**Lots 305\_306**  
**Burswood Point**

A 10 Principle Design Report  
prepared by\_

# DRP 01 Responses

The following pages outline responses to feedback received during the Design Review Panel meeting held on 23/08/2023.

Mail Room West [DRP 01]

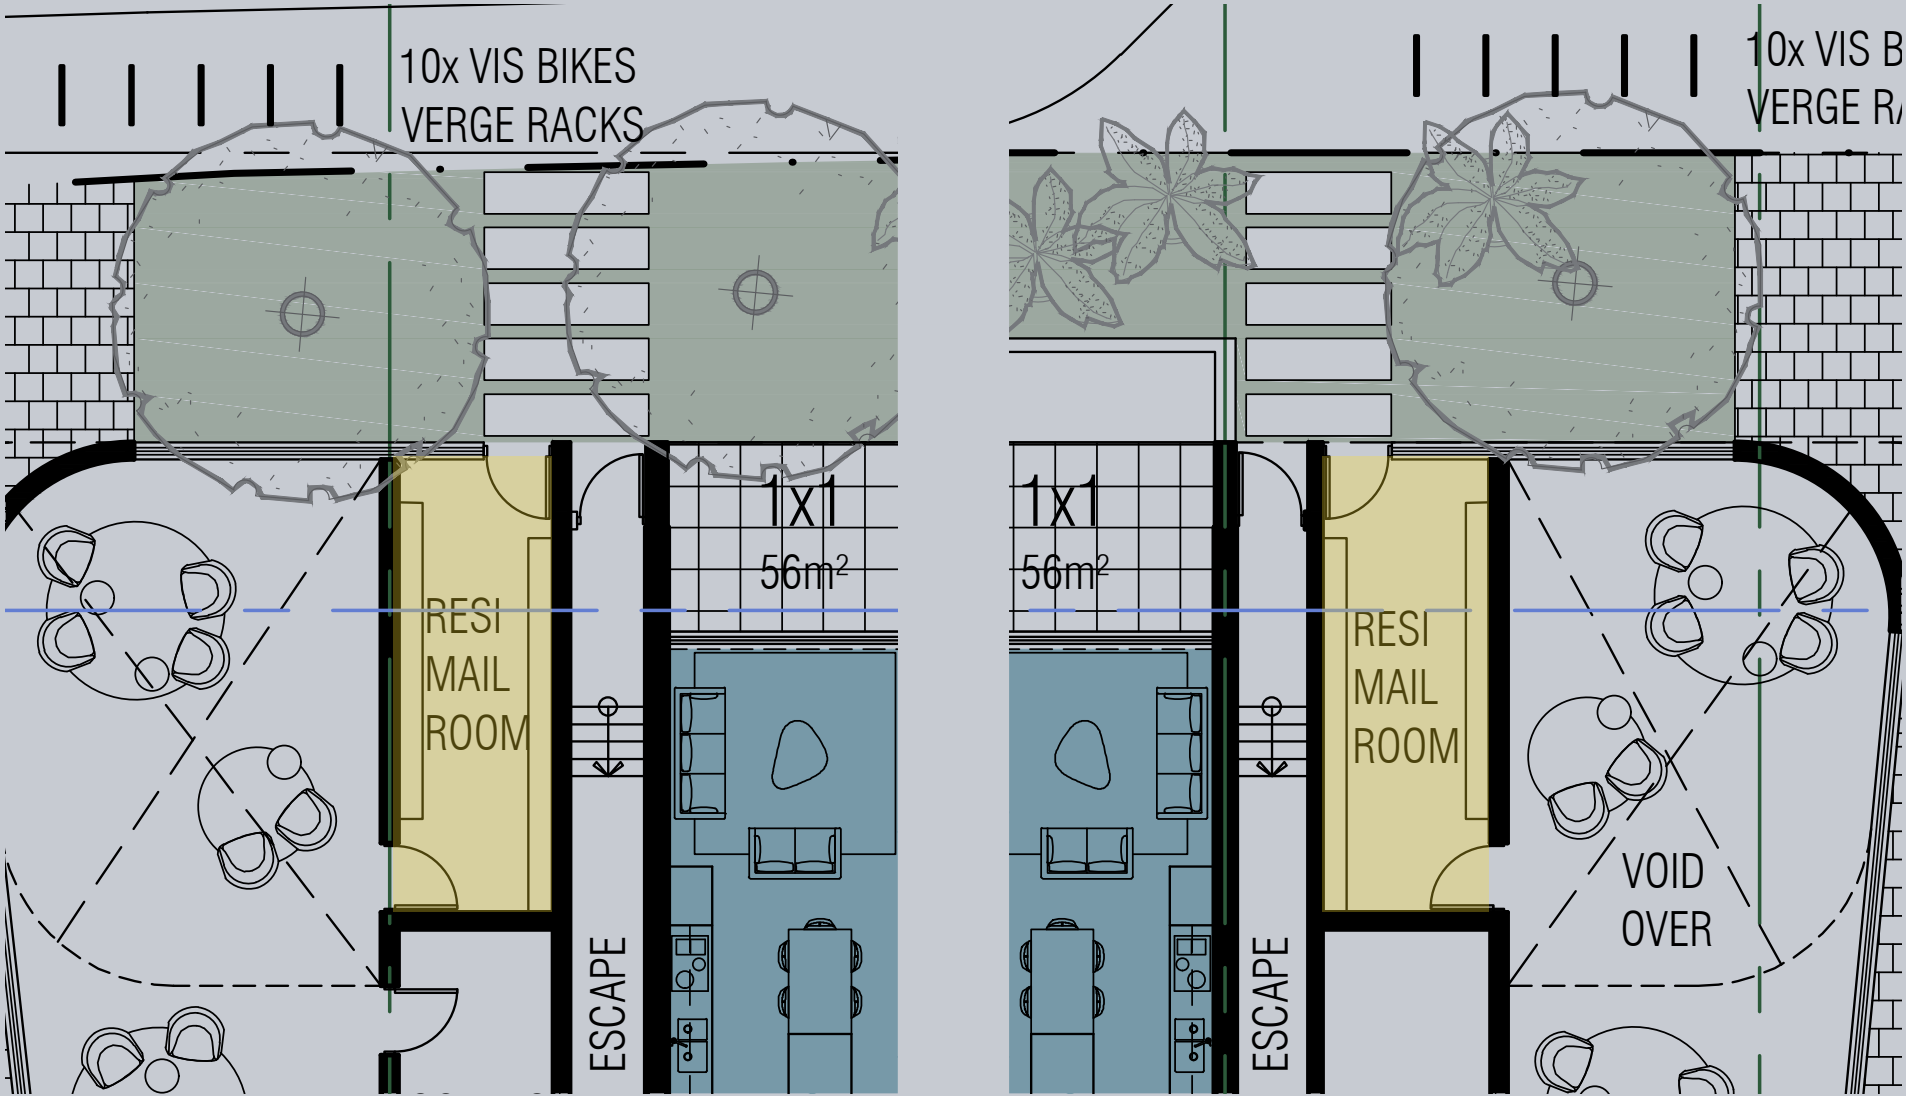
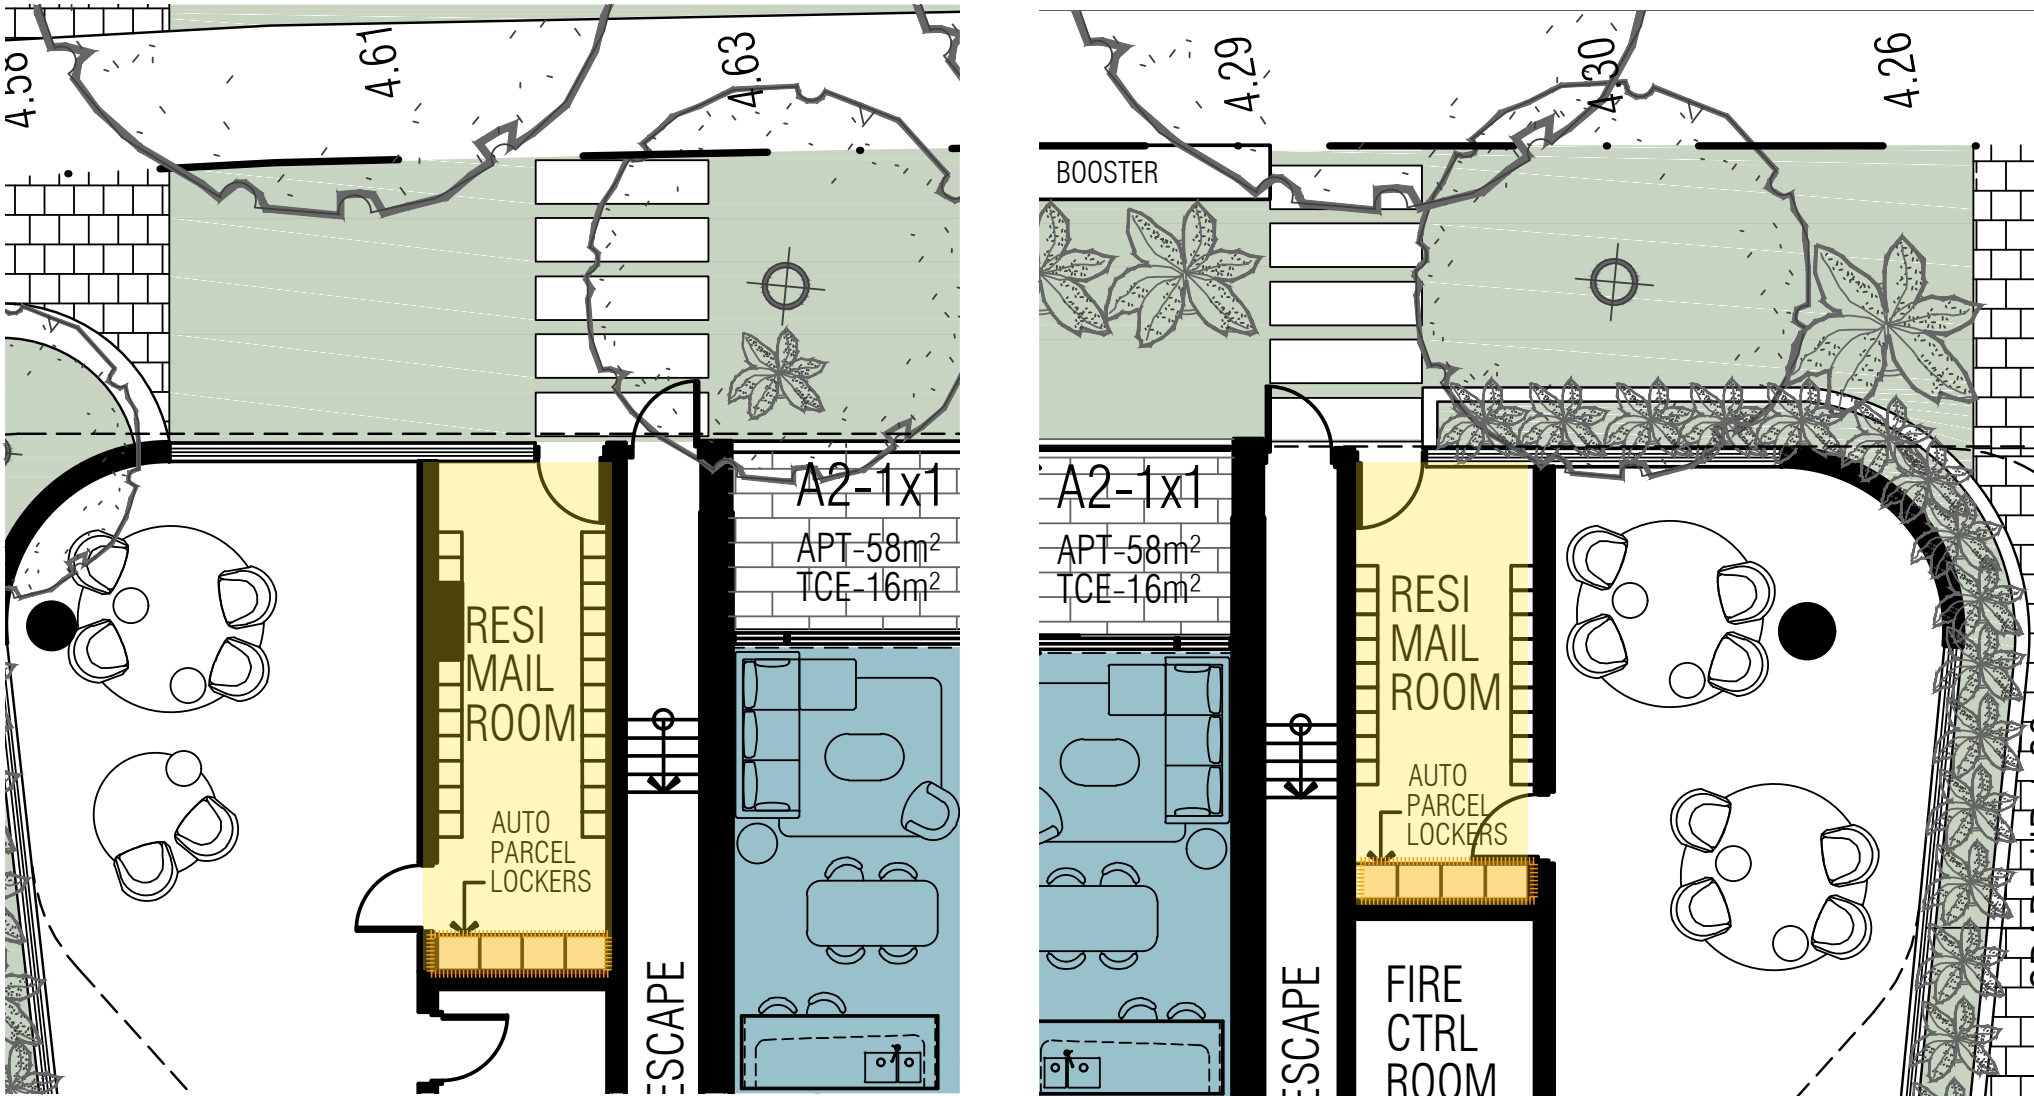
“Recommend increasing the size of the residential mailrooms to include sufficient space for **parcel lockers**.”

‘Ground Floor’ (or similar) parcel lockers included in mail rooms. Refer to following page and updated architectural set.

- + Mail rooms extended south, with dedicated space for auto parcel lockers.

DESIGN SECTION  
LOT 305 LOOKING NORTH

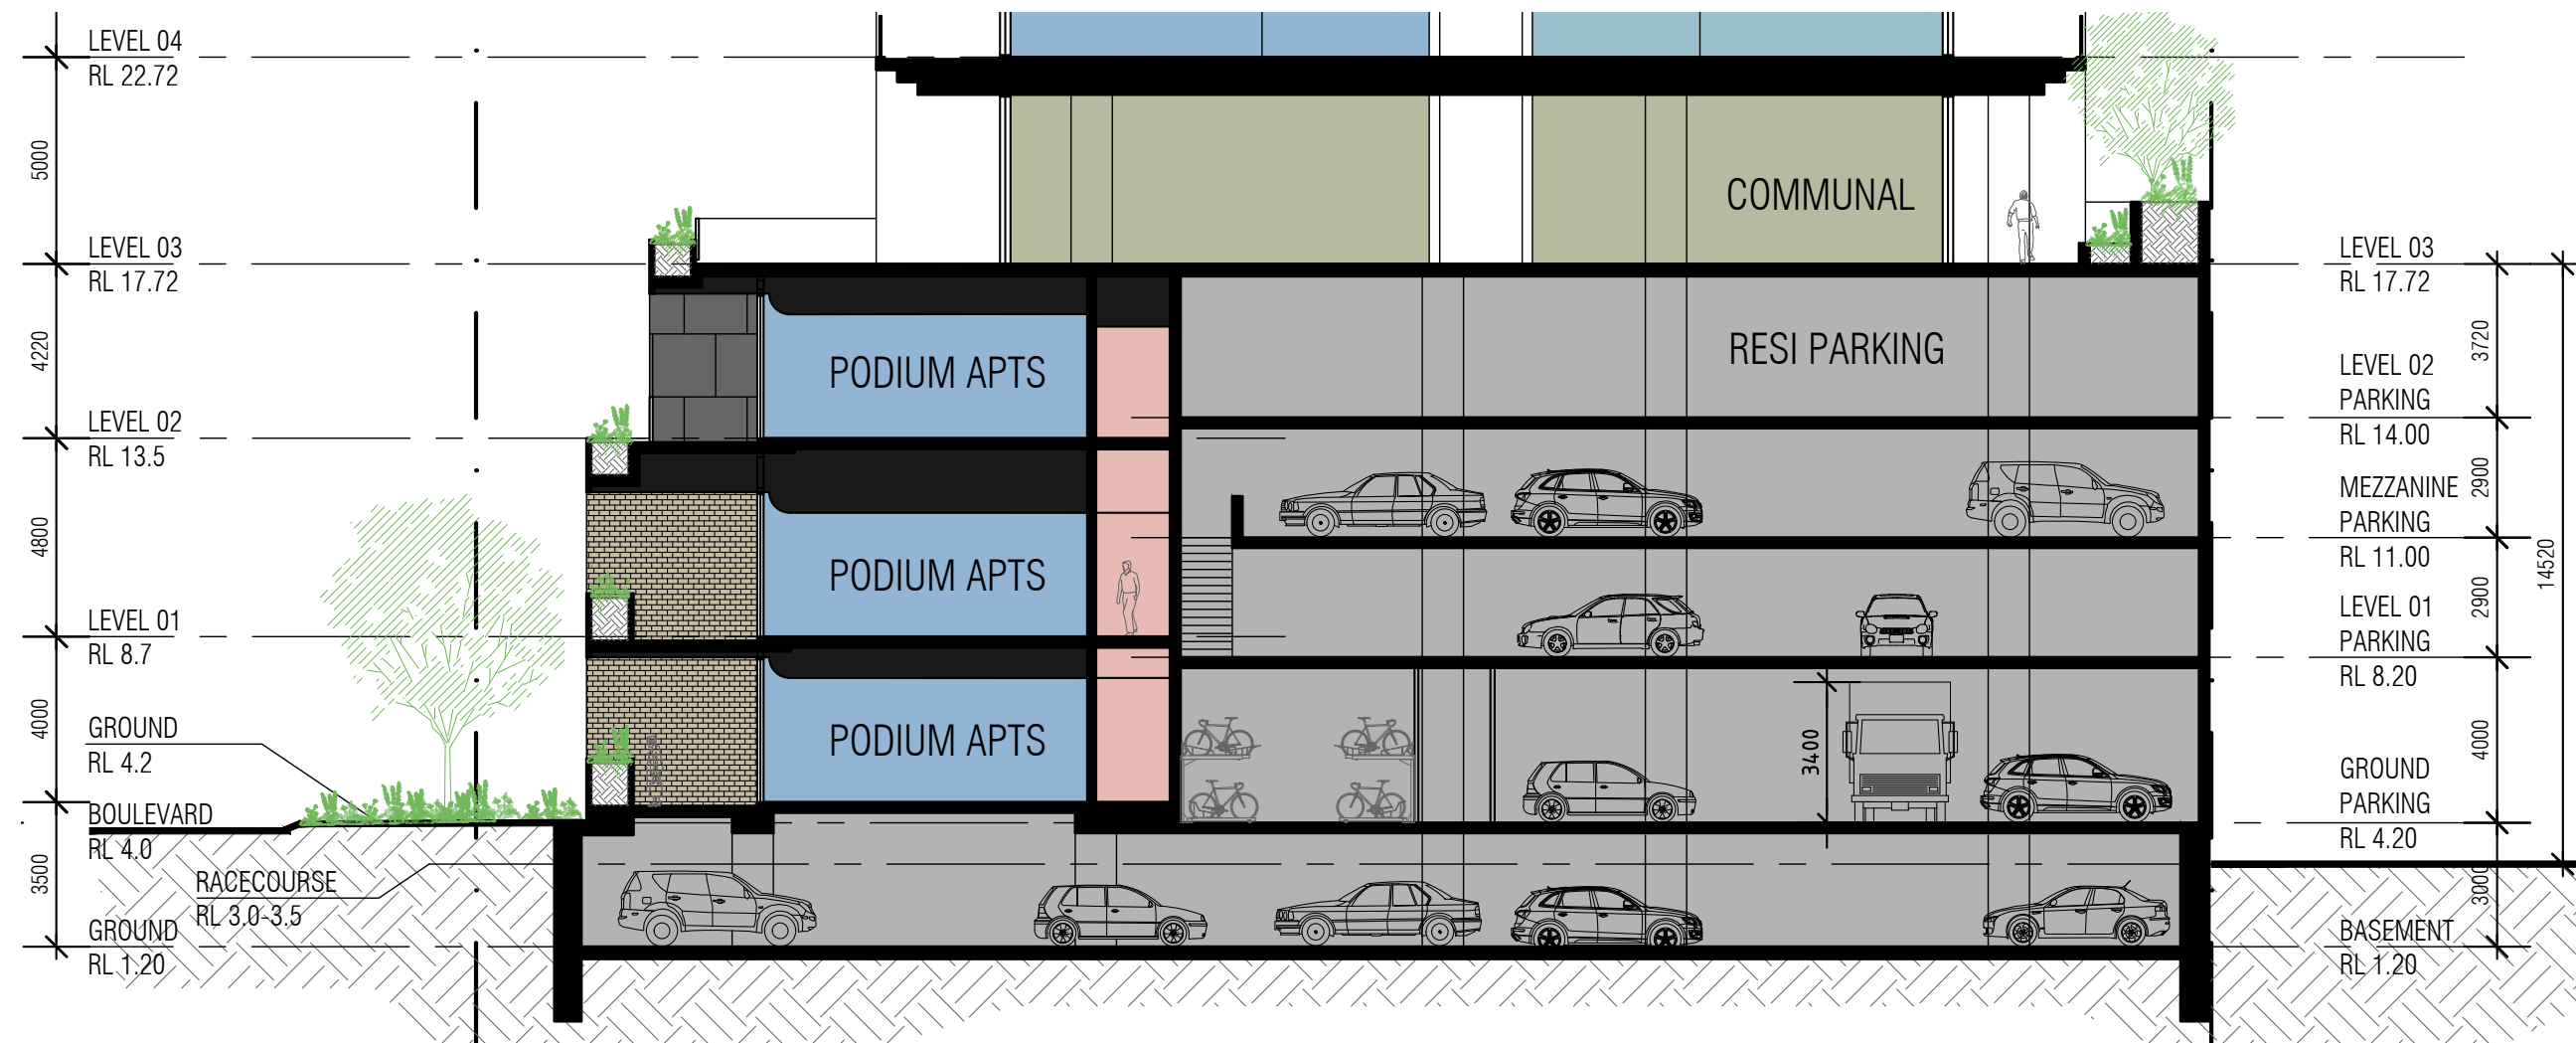
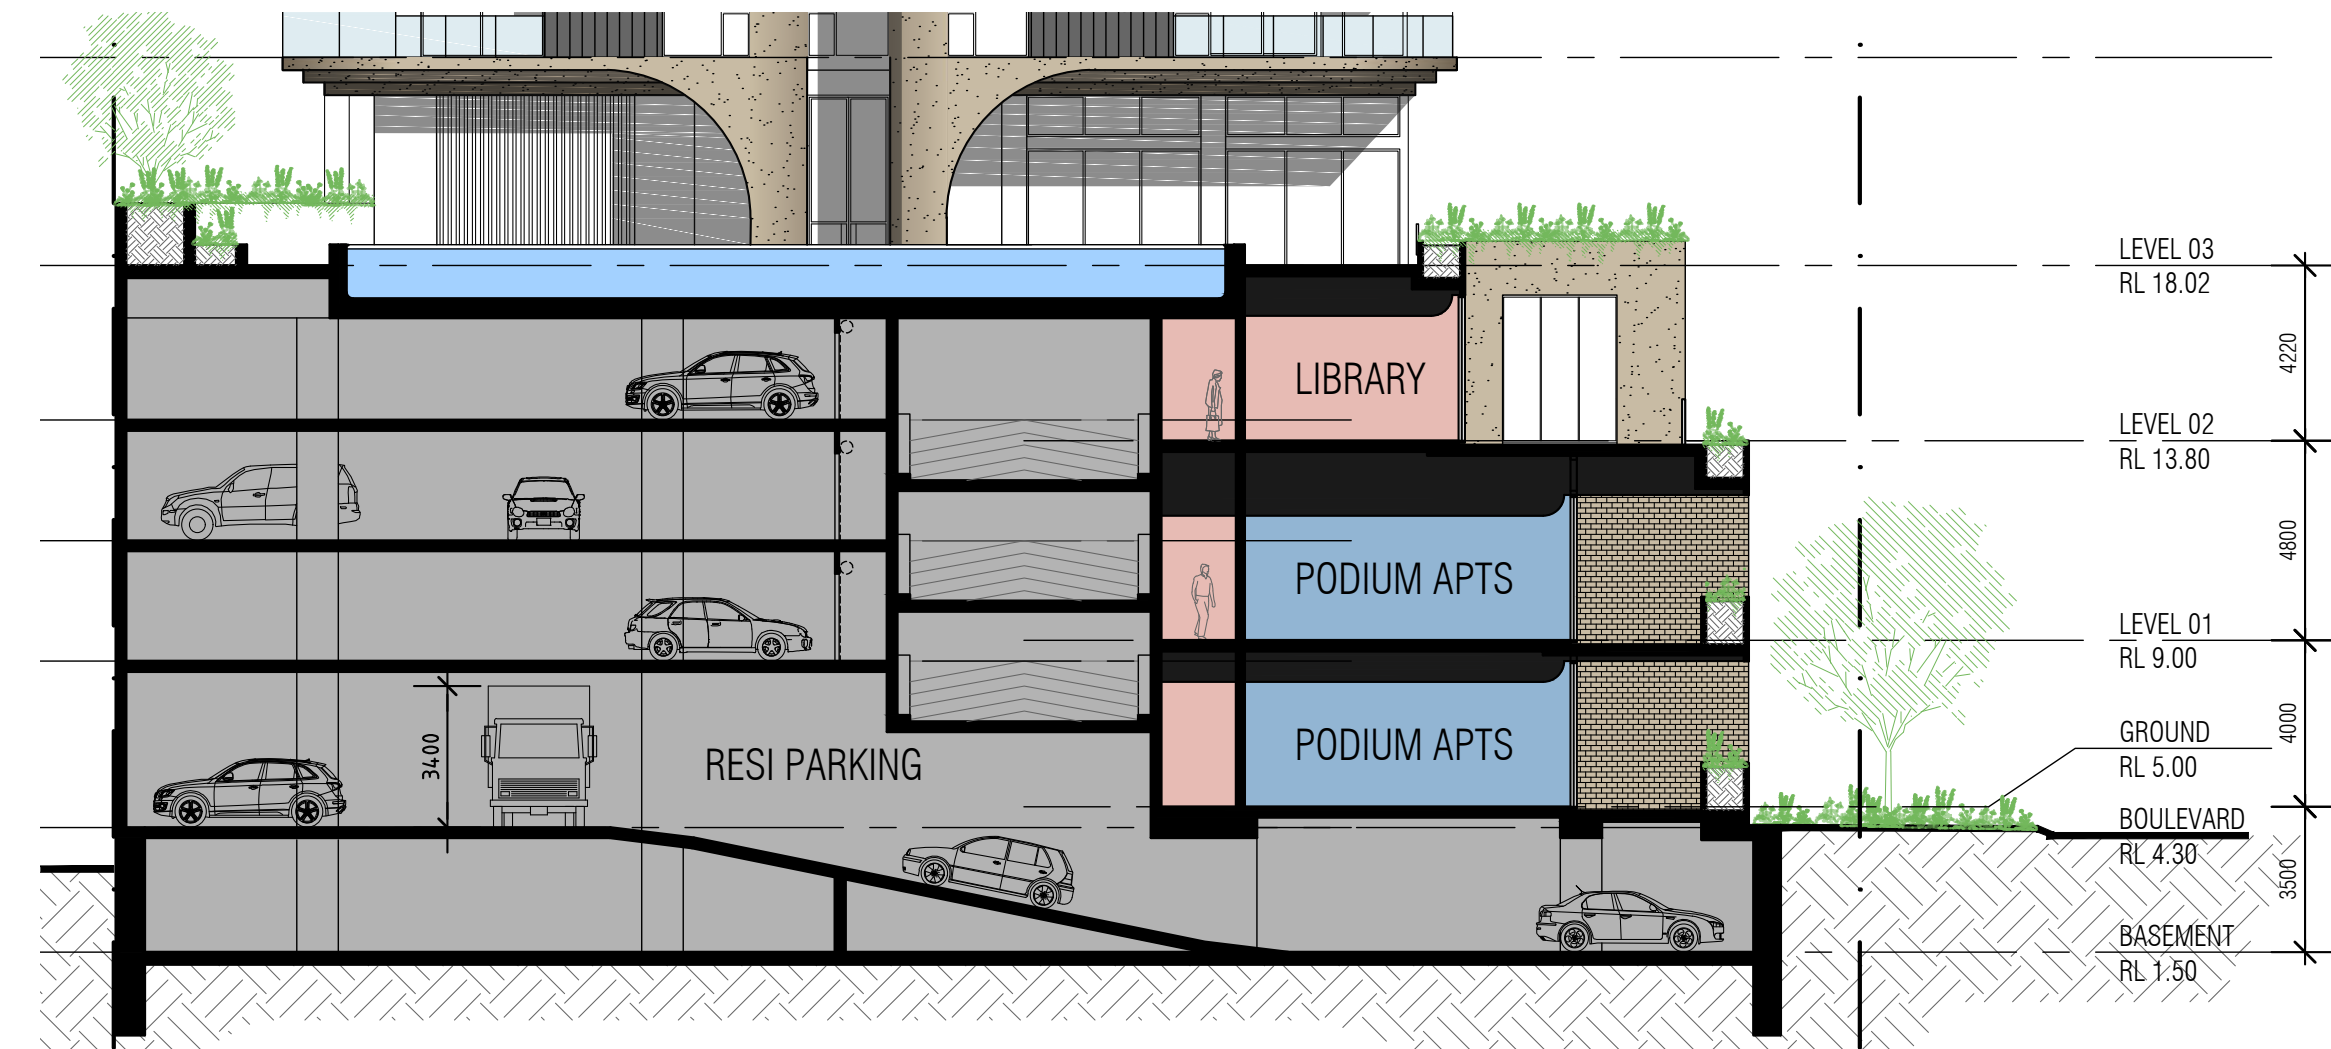
- levels on the ground level of the landscaping plan
- levels of the swimming pool area
- indicative furnishing of the communal facilities
- include cross-sections detailing how deep soil areas / depths are achieved (with reference to the basement parking & levels above)”

Refer to the following pages and the landscape DA report. Indicative communal facilities furnishings have been shown on the architectural set.

- + Podium apartments sleeve residential parking beyond.
- + Planter boxes provide balustrade to Ground and L01 apartments, flush with balcony floors for L02 and partially lowered to pool deck.
- + Ground level apartments are +700mm above the boulevard level.
